VL10 BEAMWASH

TECHNICAL NOTICE
Product	VL4000 BEAMWASH
Subject	TN - 01788

Updated firmware for the following fixtures

VL10 BEAMWASH VL10BW_091819

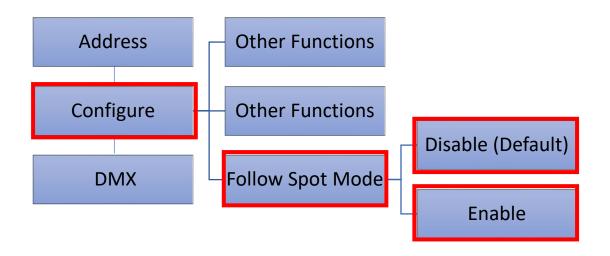
True follow spot mode -

- ➤ This allows the VL10 BEAMWASH to be used a follow spot. When activated it turns off the fixtures pan and tilt feedback system, it reduces holding current on motors so sensors remain active, but the fixture can be moved by hand with no motor restrictions or direction correction

- All other fixture functions will work via DMX in the same manner as a fixture not in follow spot mode.
- This mode is activated or deactivated via the UI only and will remain active in fixture until disabled or fixture is manually reset to default at the UI.

- ➤ If the setting is activated on fixture power start up calibration the fixture will calibrate as standard once in the home position the motors feedback and holding will switch to follow spot mode automatically.

- The fixtures UI Screen will show the light is in follow spot mode as the DMX address with turn blue and show the word follow spot mode shown above the DMX address

- ➤ On disabling the follow spot mode via the UI a full fixture power cycle or recalibration is required to re-engage the Pan and Tilt motors.

The follow spot mode can only be activated or deactivated via the User Interface see following page for updated user interface navigation
